**Town of Duanesburg  
Planning Board Agenda  
July 18, 2024**

**Re:** Kruger Energy Solar Project  
Site Plan and Special Use Permit Application Review  
KBE Project 240619-000R

We offer the following information in response relative to the project comment letter from Town Designated Engineer, Douglas Cole, PE of KB Engineering & Architecture, dated May 13, 2024, as well as comments from Town Staff and discussion during recent Planning Board meetings. Initial comments are in *italic text*, and responses are in **bold text** below using matching number system. Comments that were noted with "no further comments" or "no response necessary" have been excluded. The attached materials have been revised or are in addition to the materials submitted under previous submissions:

**C100**  
SHEET 1 OF 5

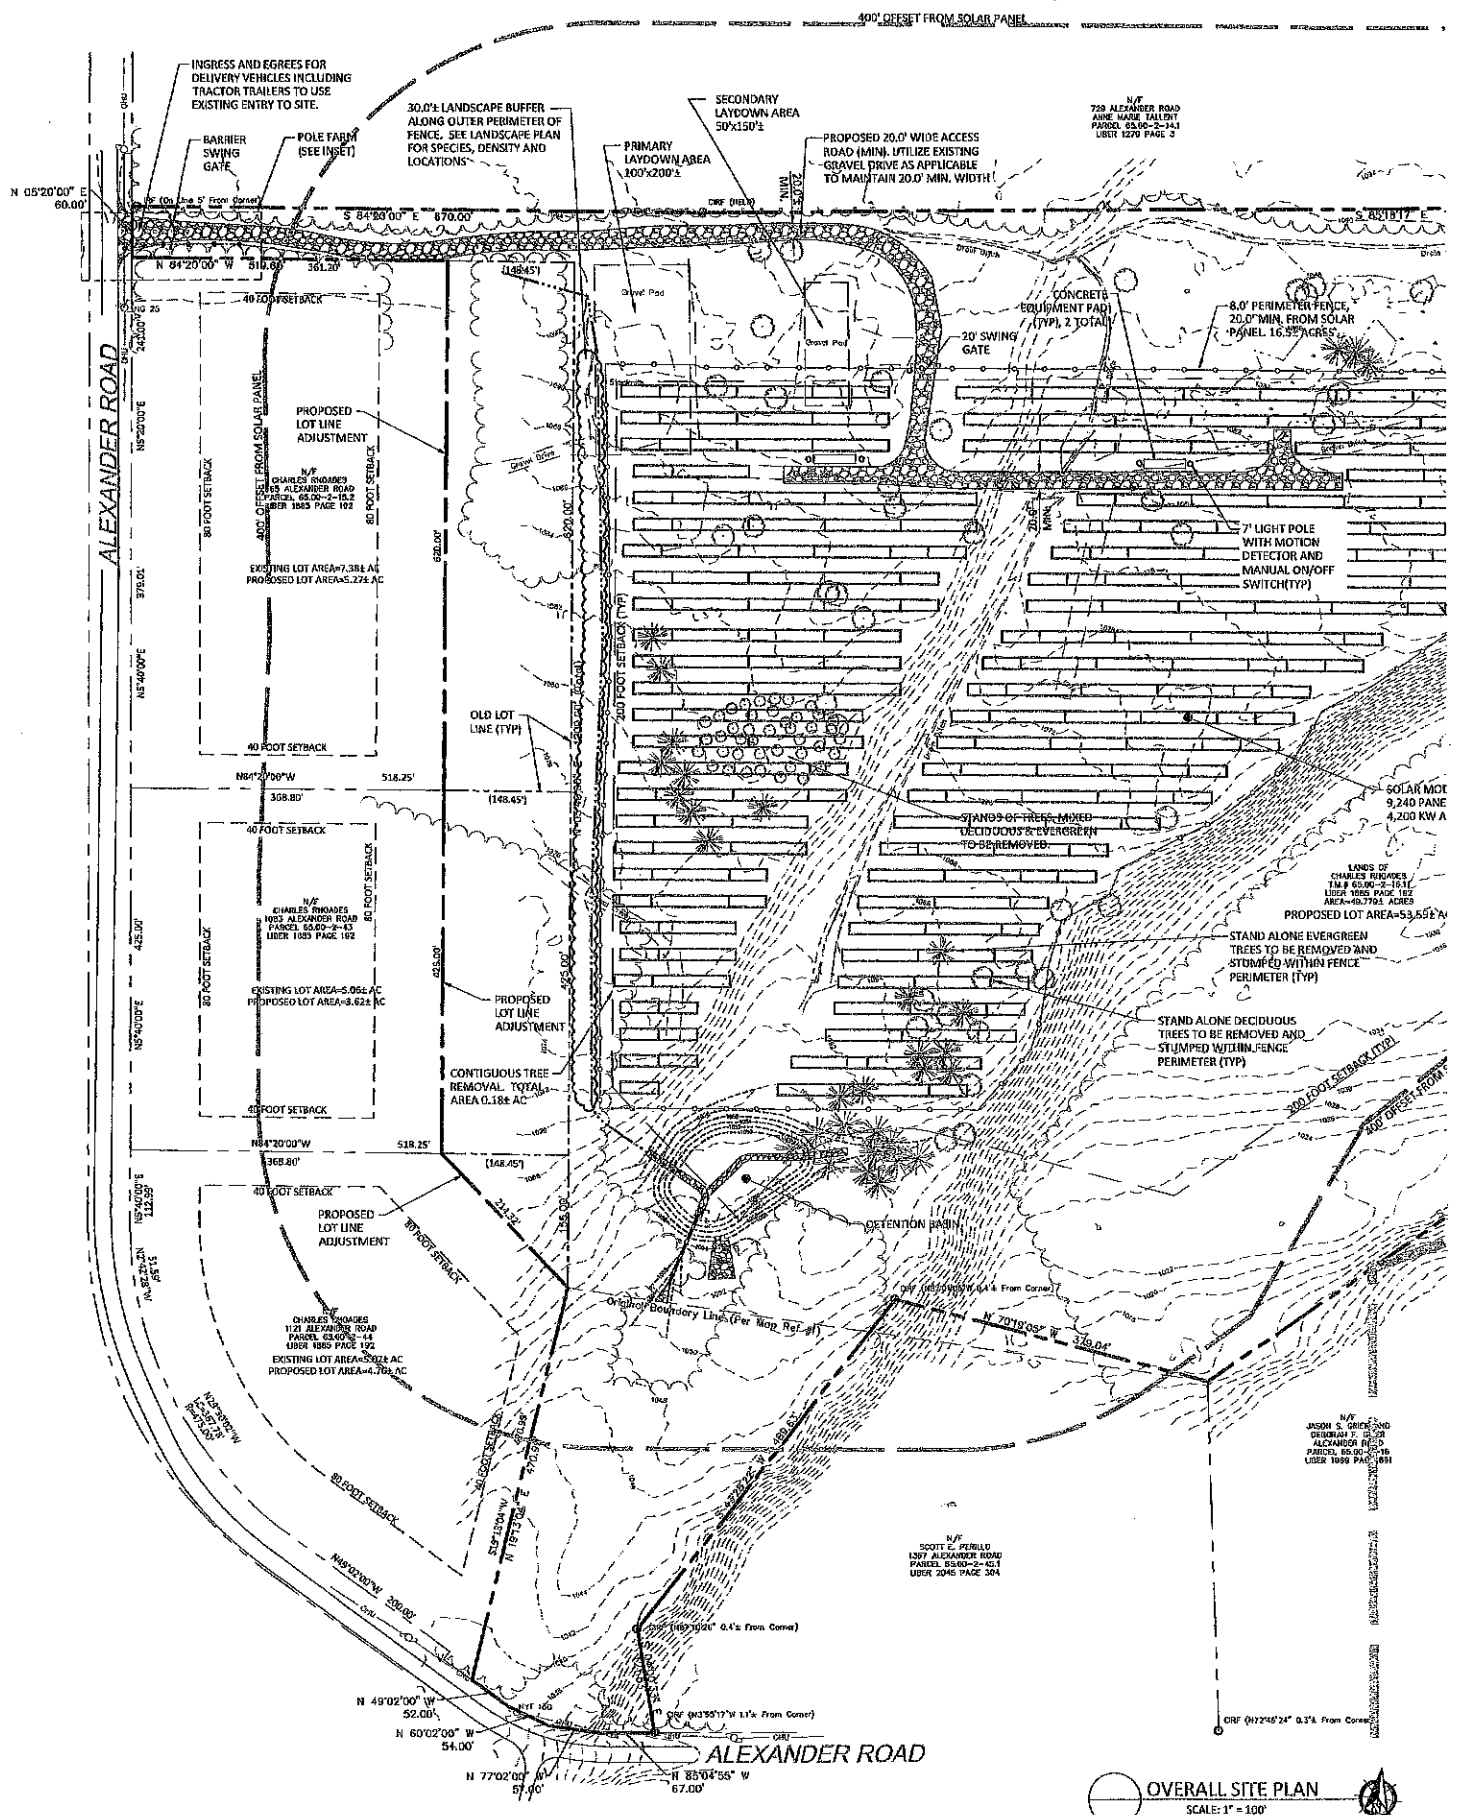
stand alone trees to be removed and stumped within the fence perimeter, and stands of trees mixed deciduous and evergreens. Sheet C-100 shows that solar panels are to be installed in the area labeled as "stands of trees, mixed deciduous & evergreen", however it is not mentioned if the trees are to be removed and stumped. It is believed that this would have to be done and should be called out on the drawing and added to the total acreage of construction disturbance. **Tree stands and individual trees within the fenced area will be removed and stumped. Trees outside the fence area will only be removed. Trees have been identified on the plans accordingly. Contiguous tree areas have also been identified on the plan and presently consists of 0.18 acres. The temporary wetland disturbance is correct at 0.73 acres, though this is a perimeter area, the actual disturbed area will be based upon placing panels supports with minimum or no vehicle traffic.**

- Gate details including location, dimensions, and design details
  - The Applicant has provided the details for the barrier gate and woven wire fence gate on Sheet C-200. The barrier gate is 4ft high and constructed of steel with a pad lock and shows additional boulders on both sides of the posts if necessary. The location of this gate should be added to Sheet C-100. The woven wire gate is 8ft high and prevents access to the solar panel field as shown on Sheet C-100. **Barrier gate has been added to Sheet C-100.**

- The Applicant has indicated that there are no proposed site improvements for stormwater management therefore the plans they provided only show existing conditions on Sheets C-100 and C-101. While post-construction stormwater management facilities are not required for projects that disturb less than once acre of land, the required erosion and sediment control practices that the contractor must follow during construction need to be shown on the plans. **After further discussion with the board, the stormwater management plan has been updated to a Full SWPPP and is included in this submission.**

- The drawing shows four (4) inverters, two (2) switchboards, and three (3) transformers, however drawing C-100 only shows two (2) concrete equipment pads. Please provide plan and elevation details of the proposed equipment pads that show all of the proposed equipment. **To clarify, diagram shows 17 string inverters, two (2) pad mounted transformers and two (2) equipment pads. Since the inverters are string inverters, they are not required to be on an equipment pad, unlike central inverters which require the pad. Equipment pad detail has been included in the plans set.**

ACCESS DRIVE SECTION

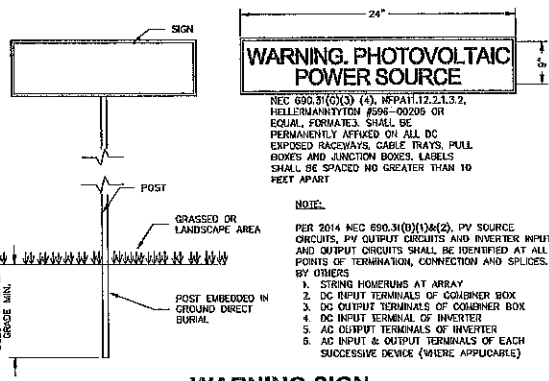
- Access road details
  - The Applicant has clarified that they will be using the existing gravel/stone road access for the project and that only minor expansion will be required to maintain the 20ft width. This has been shown on Sheet C-101. The width and materials for the existing access road meet the Town of Duanesburg Solar Law that requires access roads to be no wider than 26ft, however a detail should be provided for the proposed expansion areas for the access road to confirm that it will not be made of impervious materials. **The detail has been provided to show the expansion area and materials to be used where the road will be widened to 20.0 ft.**

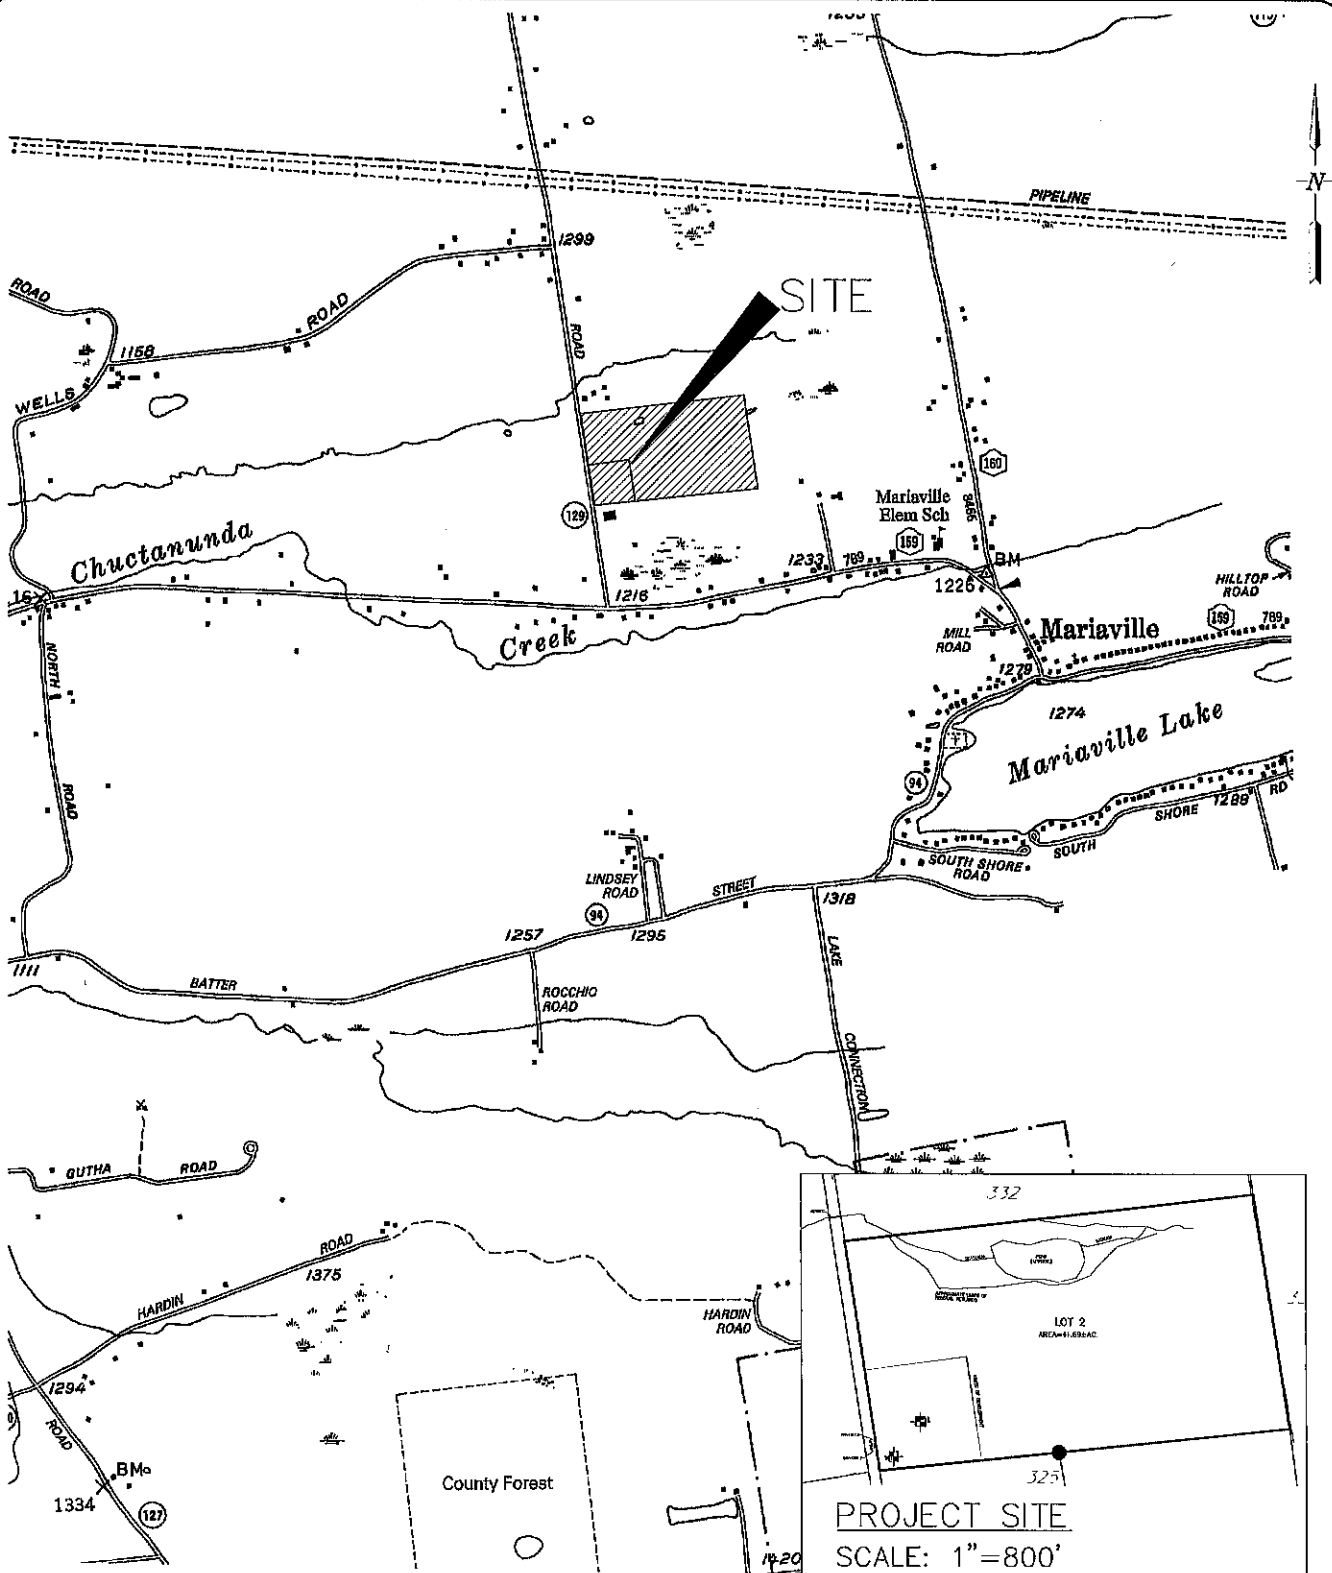
Comment 1: Please provide the location of the NYSDEC wetland located on the adjoining parcel to the south of the project parcel. Please provide the location of the 100' wetland buffer on the plan to ensure that the proposed area of development is not located in the buffer.

Comment 2: Please provide the limit of the ACOE wetland area associated with the pond along the northern property line to ensure that the proposed area of development is not located within the wetland area.

Comment 3: The Planning Board advises that the remainder of the acreage is non-buildable unless and until detailed wetland delineation approved in writing by NYSDEC is performed. A note to that effect should be included in the final plan.

**Response: The location of the NYSDEC wetland and the 100' buffer are shown on the plan.**

**Response: The approximate limits of the ACOE wetlands are shown on the plan.**

**Response 3: Note 3 on the plan has been updated to include this note.**
